SERVICE INFORMATION NO. SI 42NG-087

Austro Engine Mandatory Service Bulletin No. MSB-E4-024/1

No. MSB-E4-024/1

Waste gate – Spring loaded circlip

Example: Turbo charger for engine configuration "-A" with new spring loaded circlip

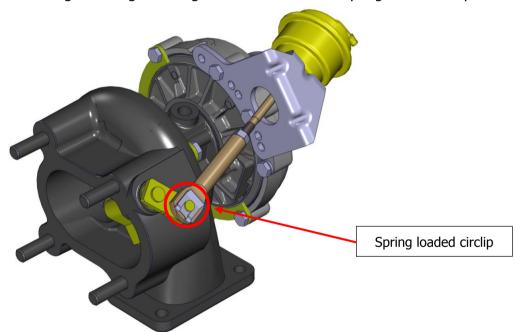
This Service Bulletin describes the replacement of the waste gate circlip, which prevents the waste gate actuator connection rod from disconnecting from the waste gate bolt of the turbo charger. An improved circlip design prevents the incorrect installation of the circlip.

Replace the circlip DIN6799-5 with the spring loaded circlip E4A-41-100-801.
